ADDENDUM No. 5

Date: November 26, 2019
To: All Bidders
From: **Jenkins•Peer Architects**
Charlotte, N.C.
Re: UNC Charlotte – Residence Hall Phase XVI
SCO ID: 18-18333-02A
JPA Project #: 18NCC016

1 LOWER LEVEL TELECOMMUNICATIONS PLAN - SOUTH
1/8" = 1'-0"

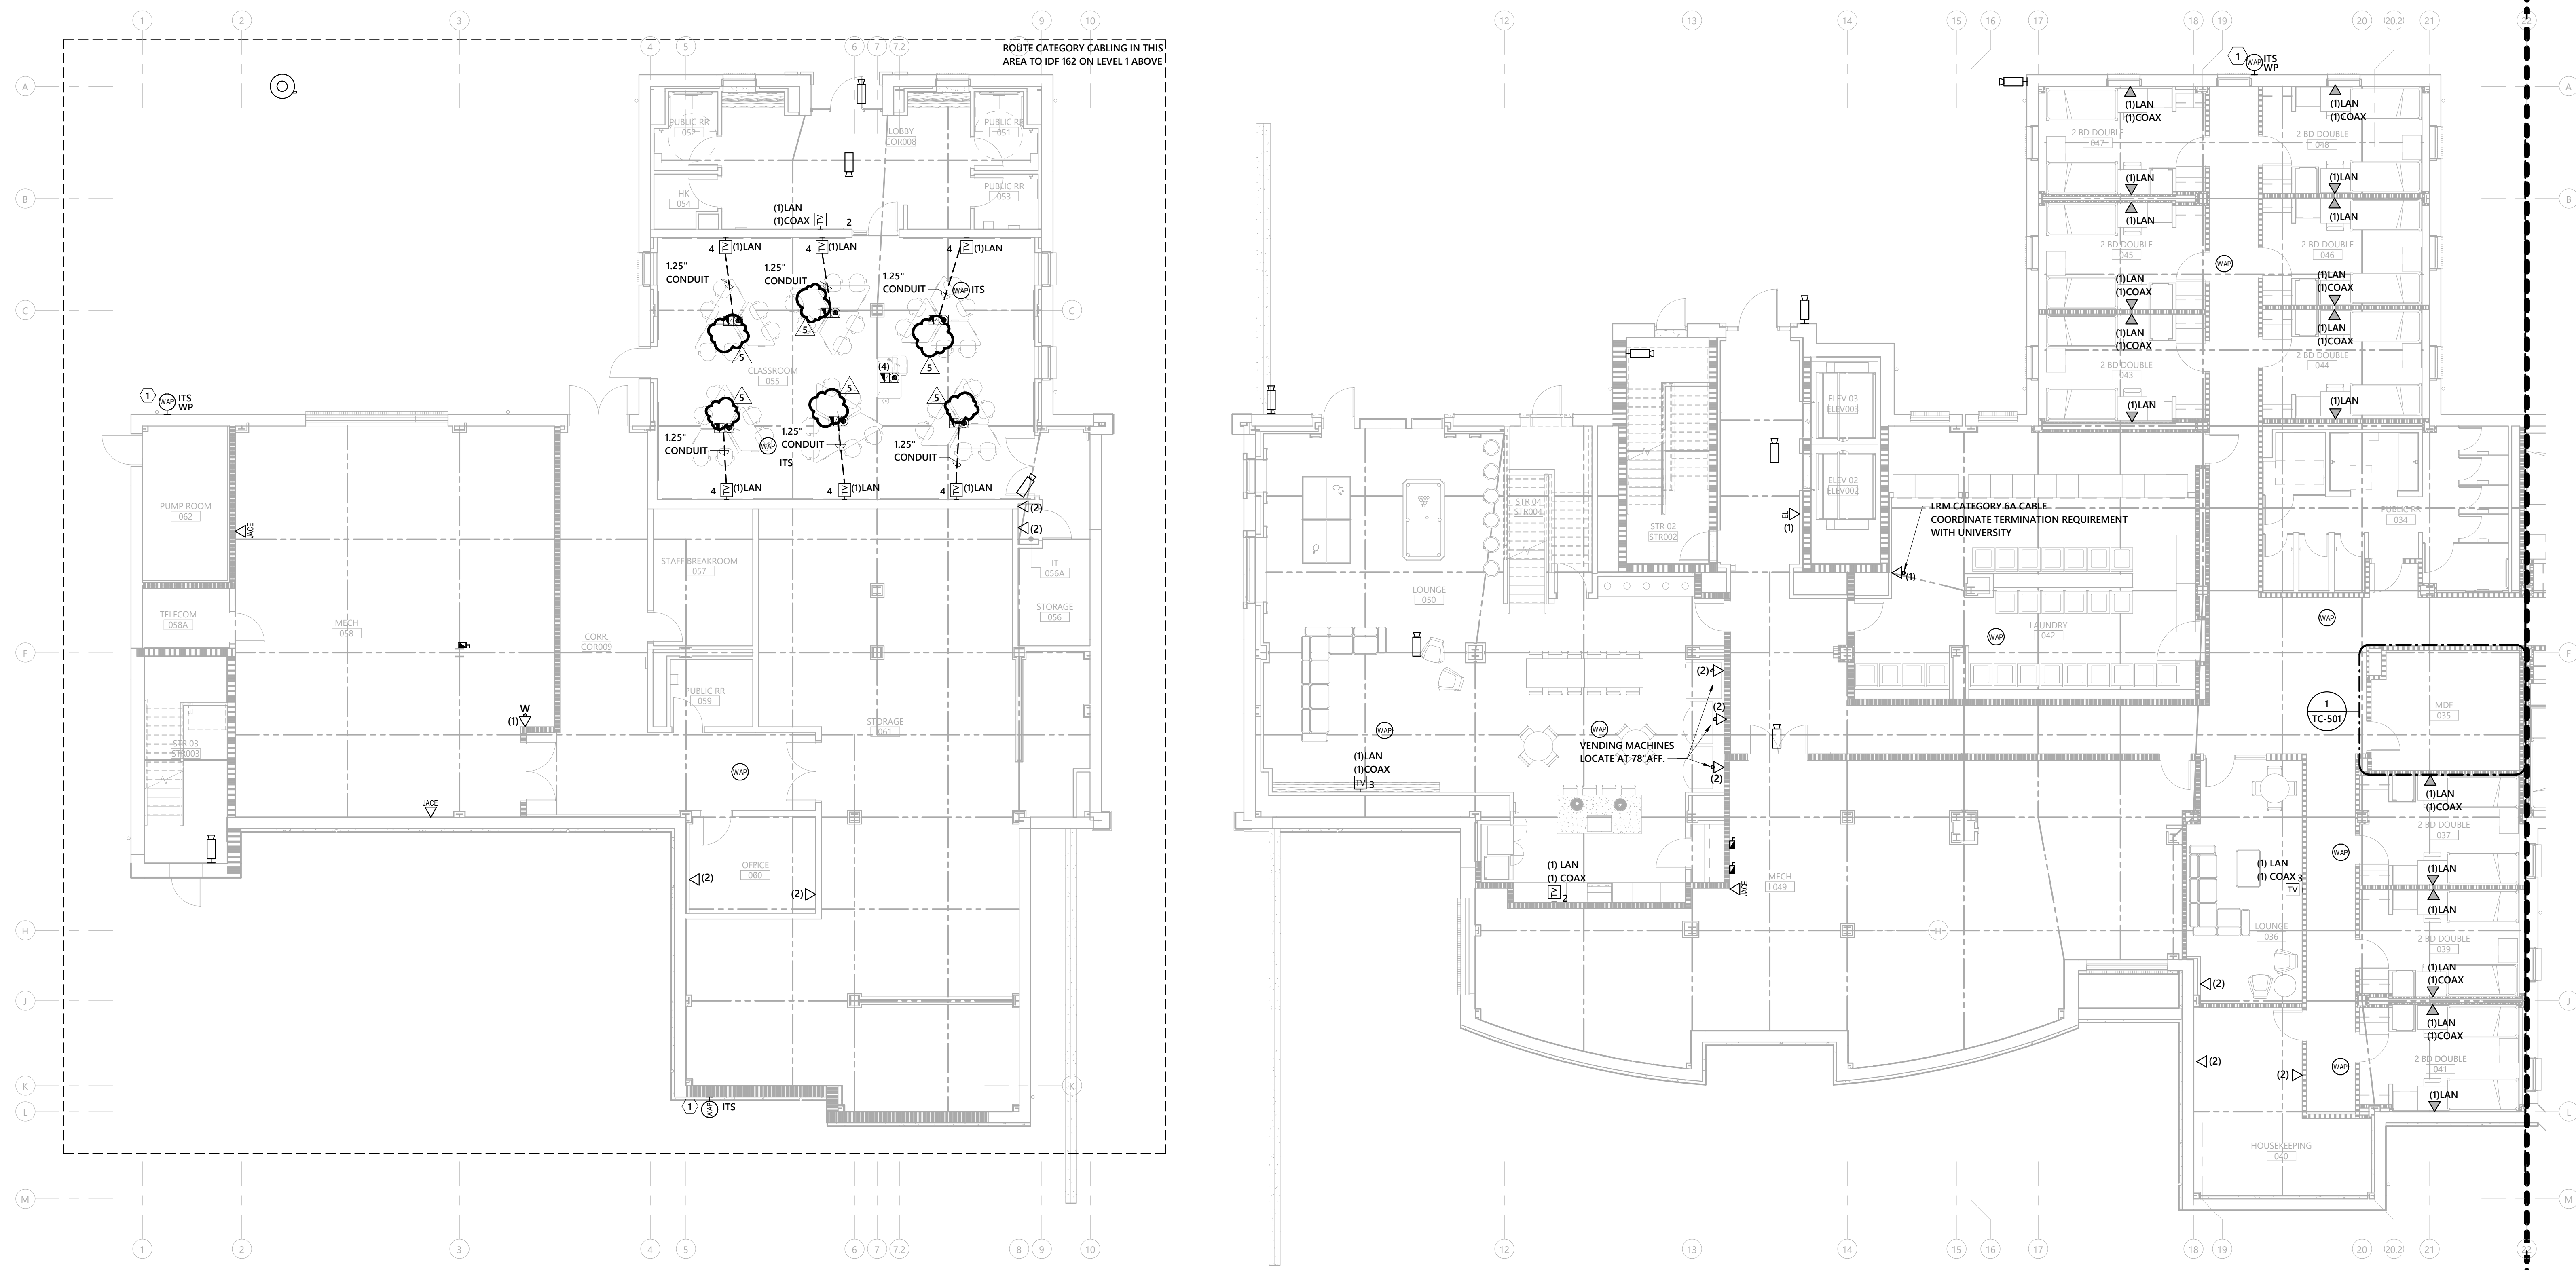
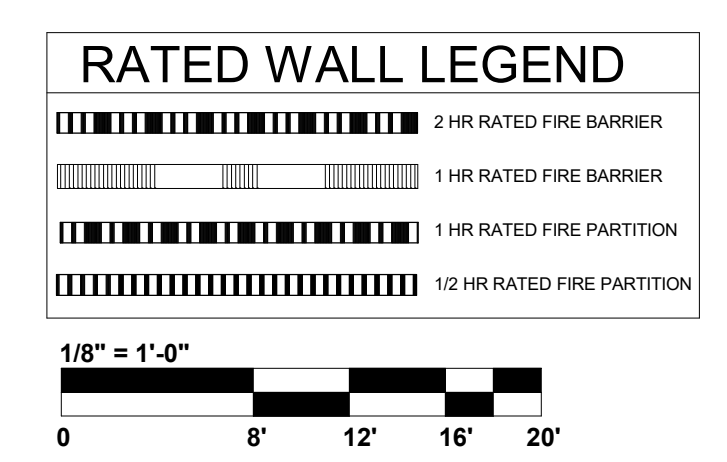
QUESTION: Drawing TC-100-S Class Room 055 has a drawing note 2 next to the floor boxes. There is no Indication on the legend of this drawing describing what drawing note 2 is referring to.

QUESTION: What does this detail indicate as I cannot find the Exterior Network Device Detail in the Telecommunications section 11?

RESPONSE: Note 2 is no longer used and shall be deleted.

RESPONSE: Refer to detail 3/TC-601

TC-501

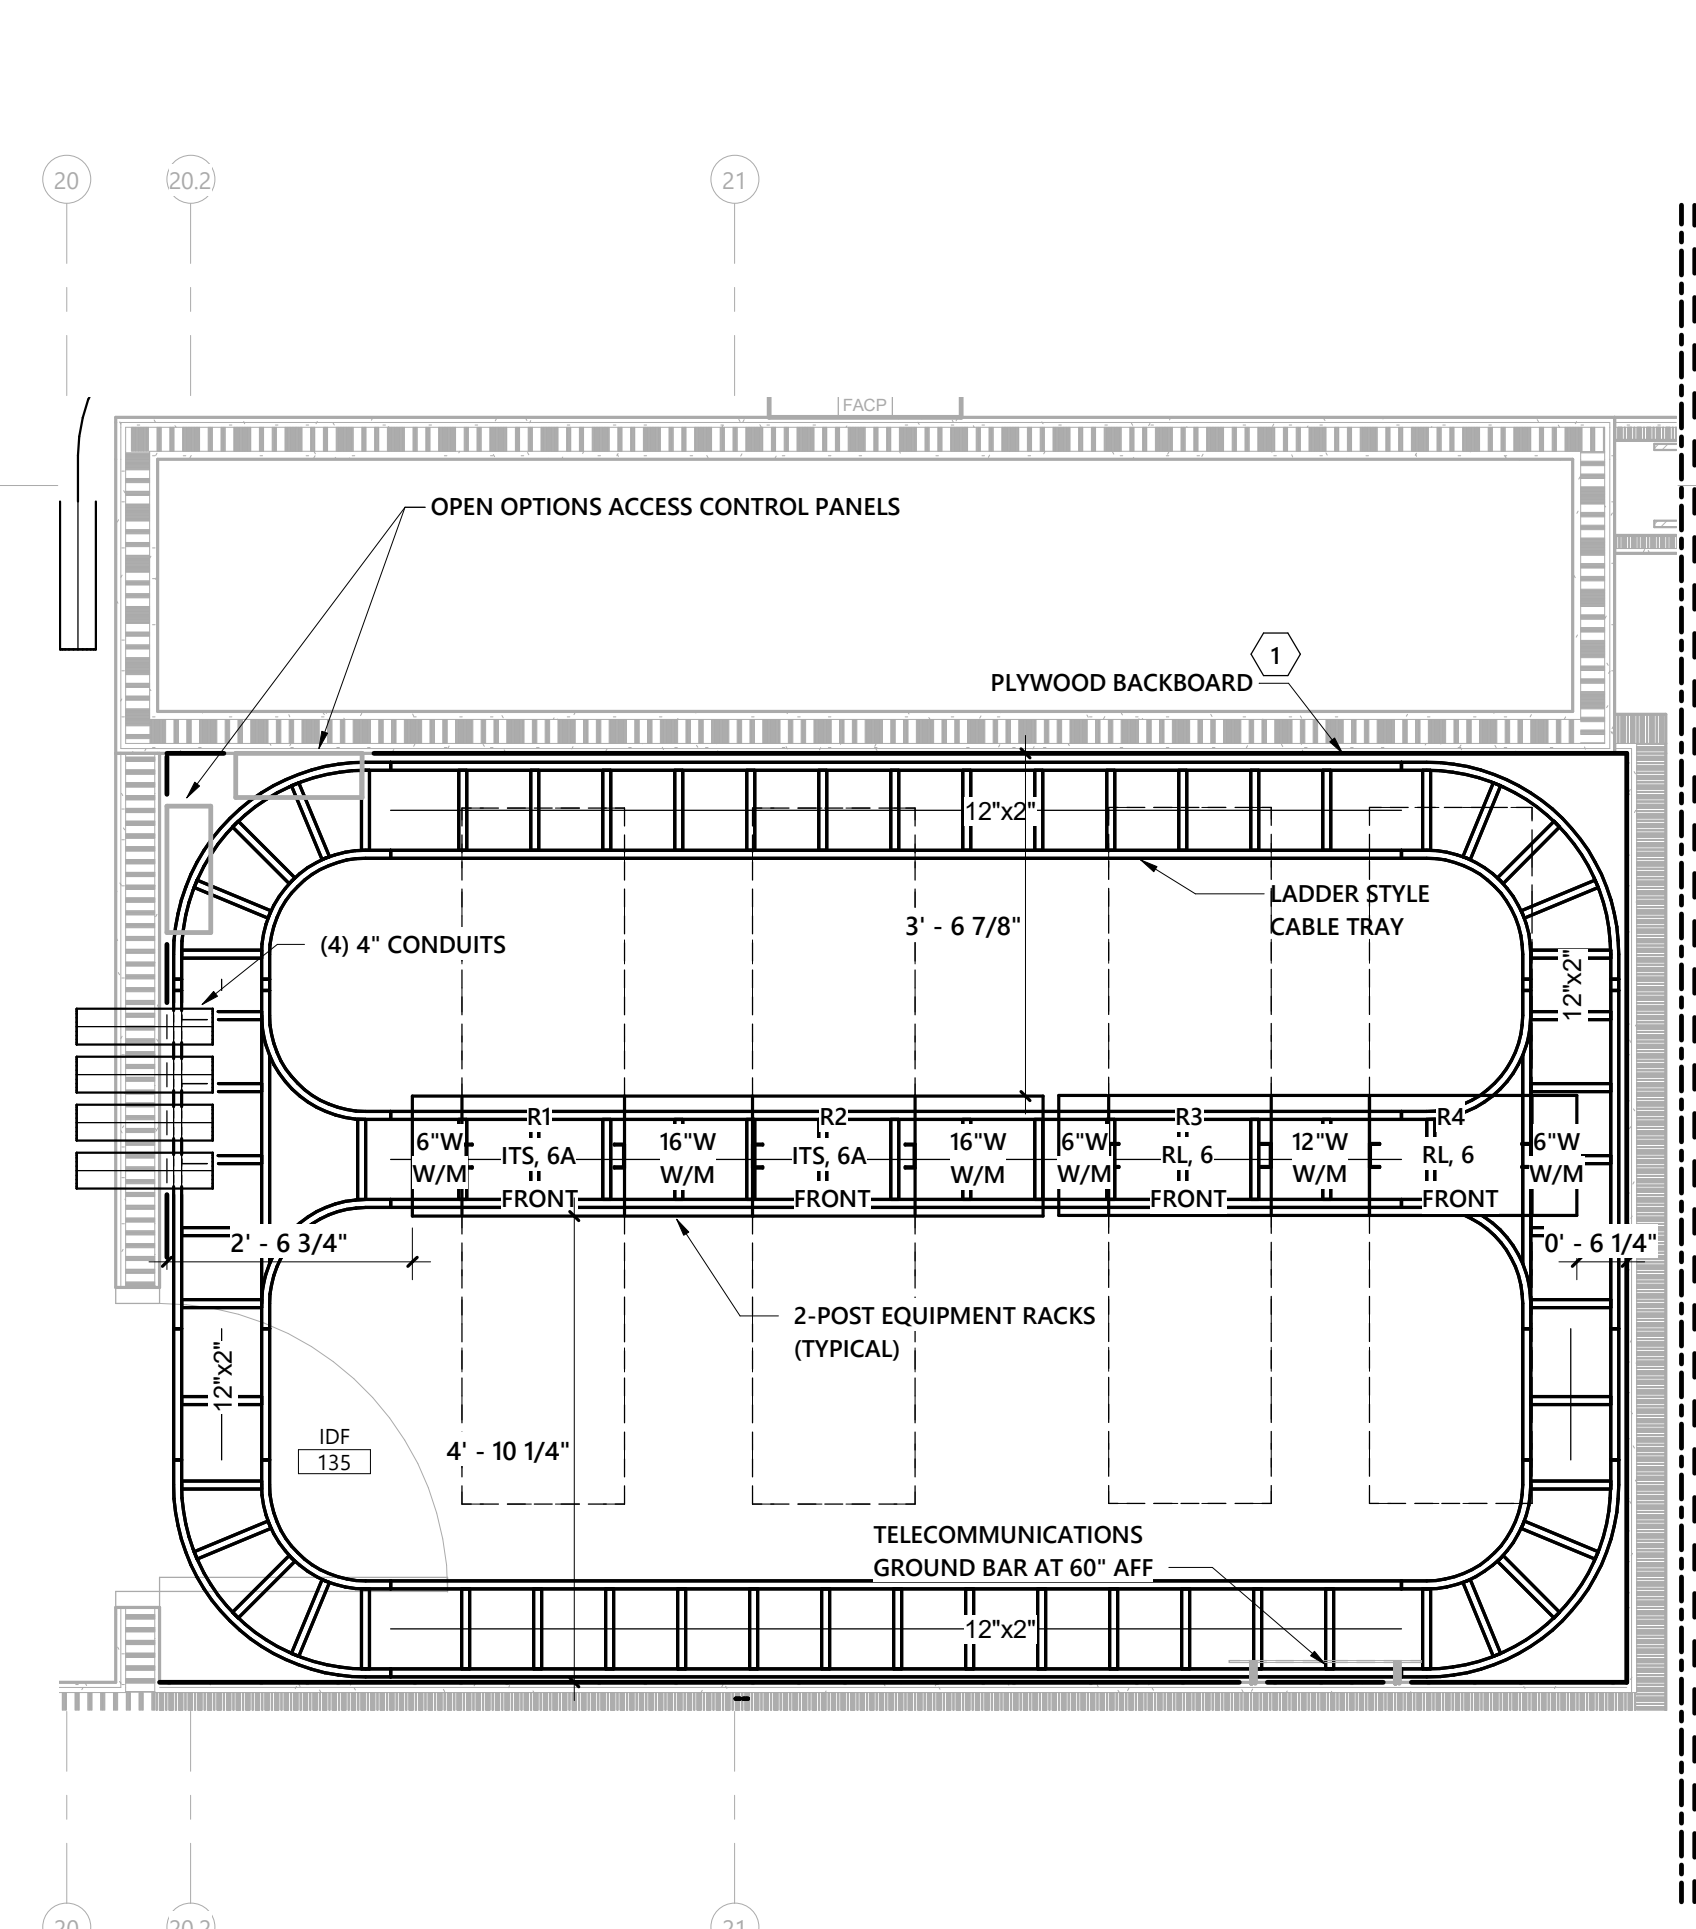
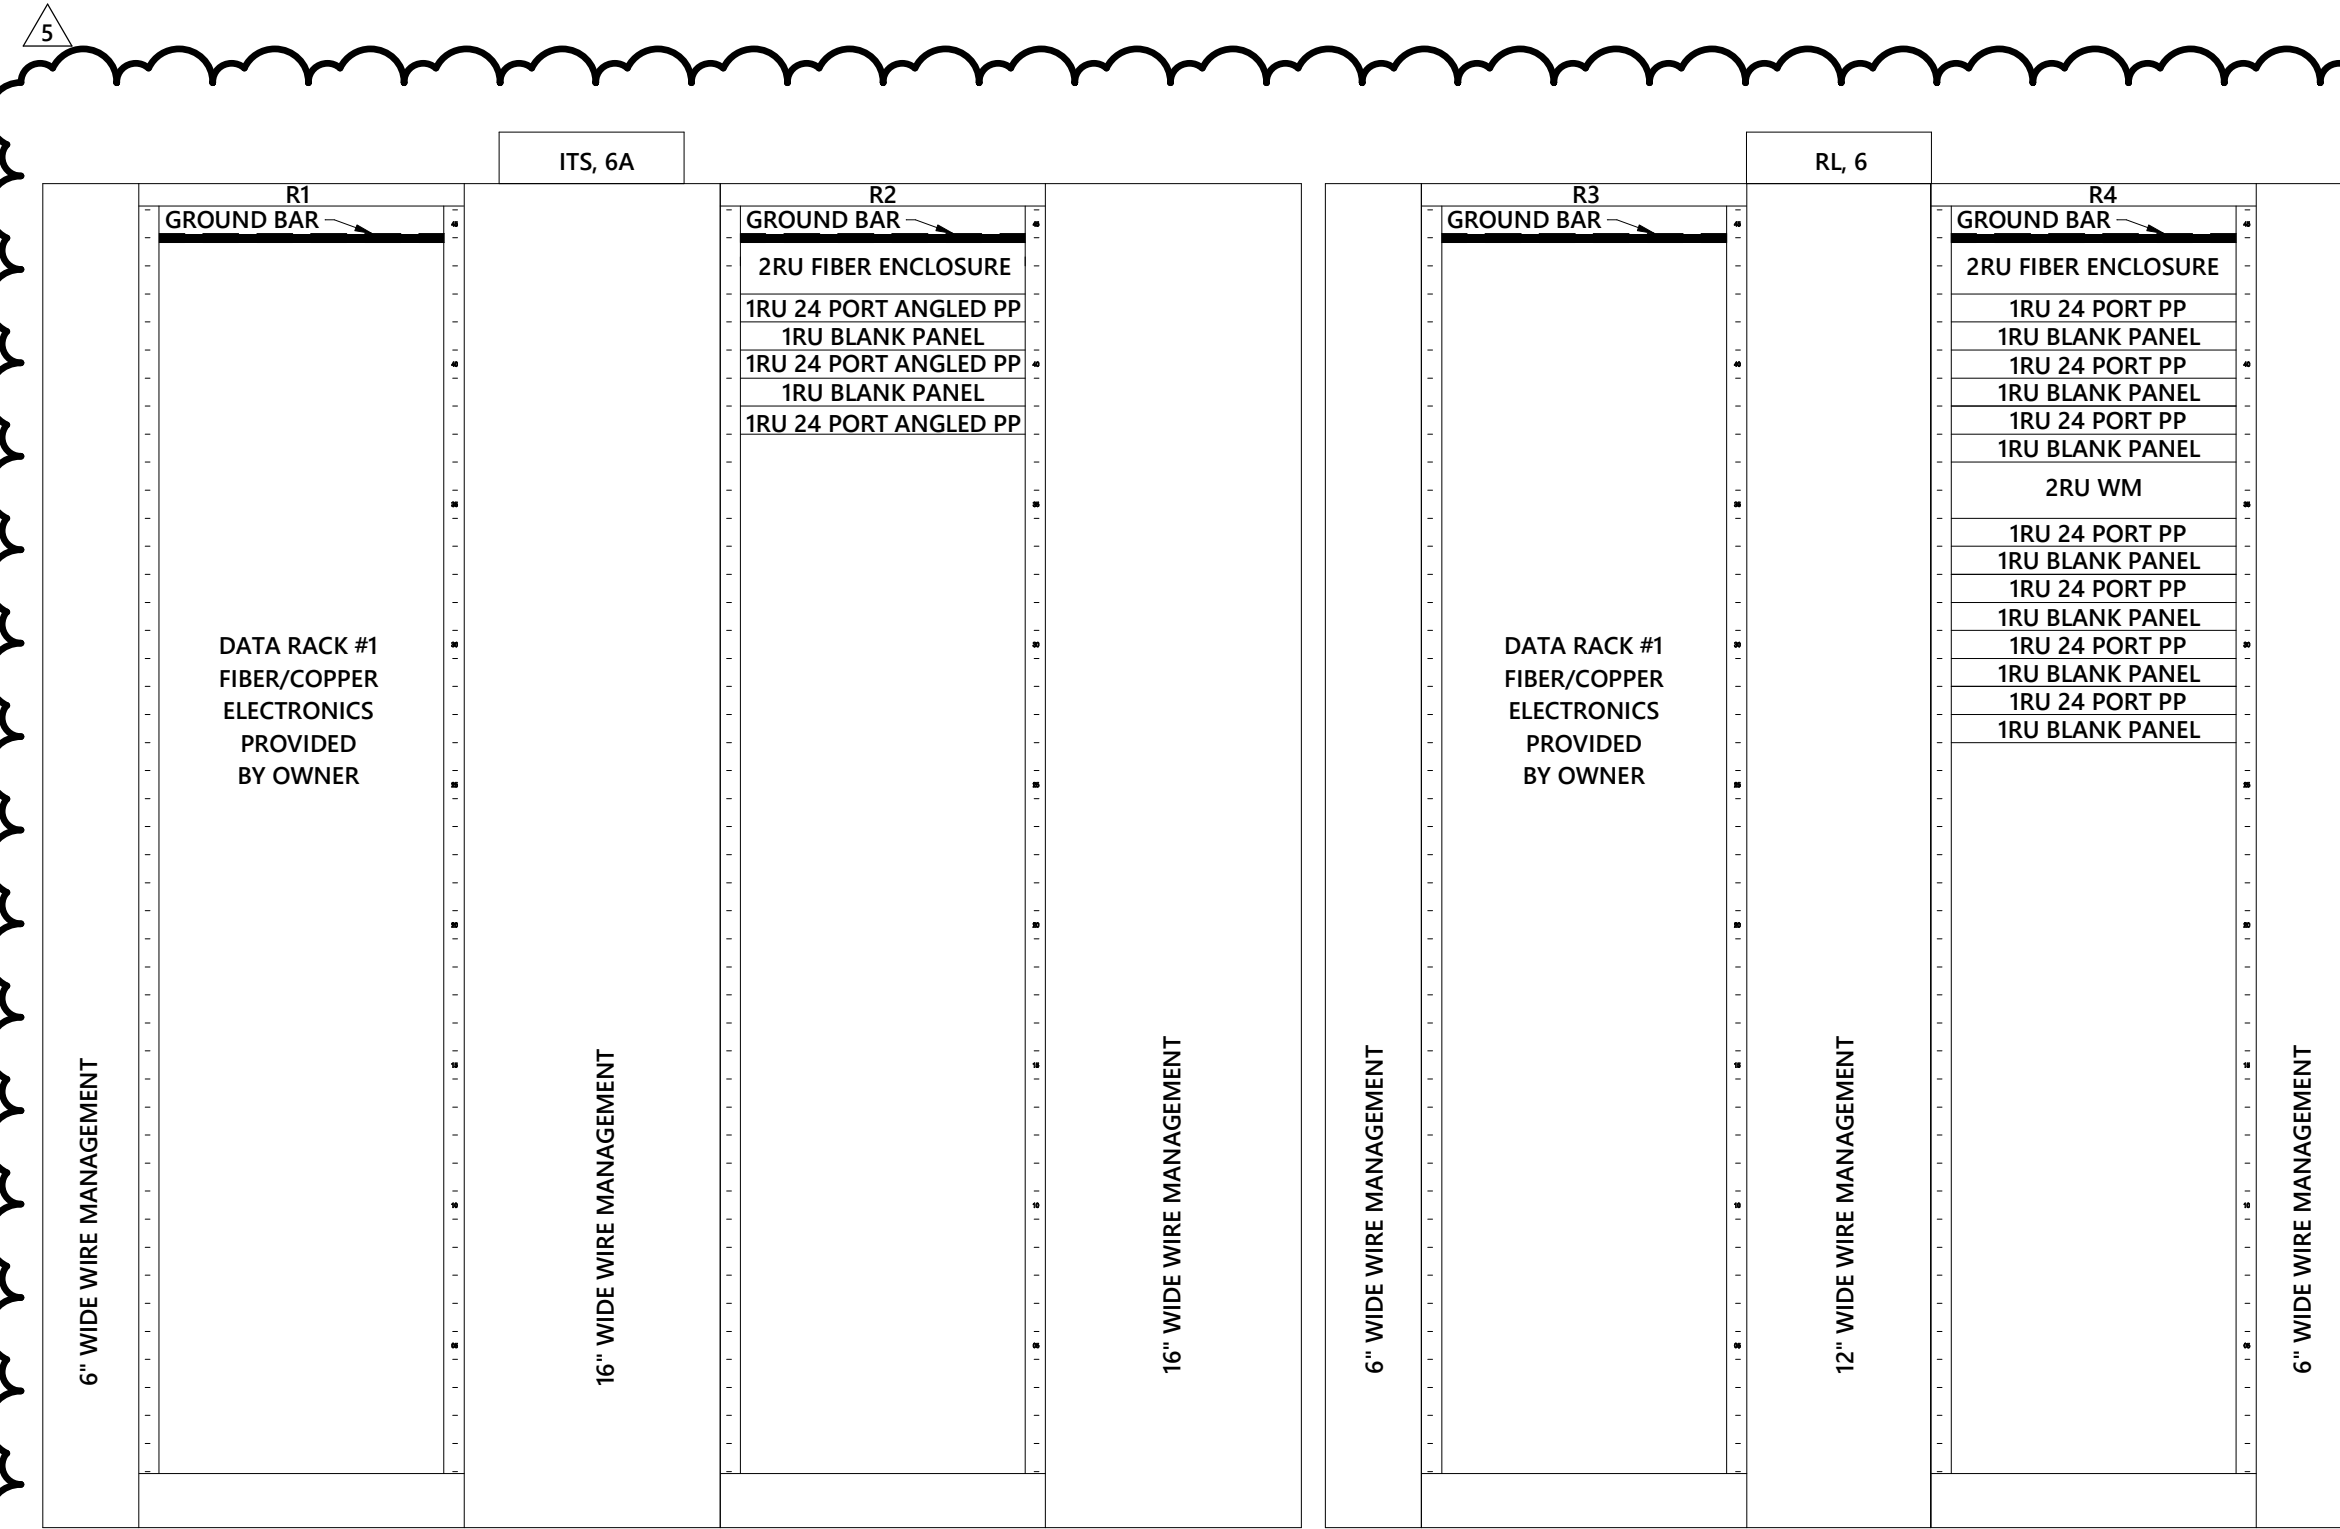
QUESTION: The legend (drawing TC-000) has two different types of WAP symbols. One type gets 2 CAT 6 cables. The second type with the subscript ITS gets 2 Cat 6A cables. The rack elevations only shows patch panels space for CAT6A WAP (yellow) cables. Do all WAPs get 2 CAT 6A cables or is there a mixture of CAT 6 and CAT 6A WAP outlets and the rack elevations need to have a CAT 6 panel for CAT 6 WAP cables?

QUESTION: Drawing TC-501 (rack elevations) does not show which rack the backbone fiber or the 25 pair copper should terminate in. Also what size fiber enclosure is required?

RESPONSE: There are two different types of WAPs with different cabling requirements. ITS cabling shall be terminated on ITS patch panel and Resident Life shall be terminated on RL patch panels in associated racks. Rack elevations will be updated for clarity.

RESPONSE: Terminate fiber optic cable in RL rack and 25 pair copper on patch panel in IDFs. Provide a 2RU enclosure for fiber connectivity. Rack elevations will be updated for clarity.
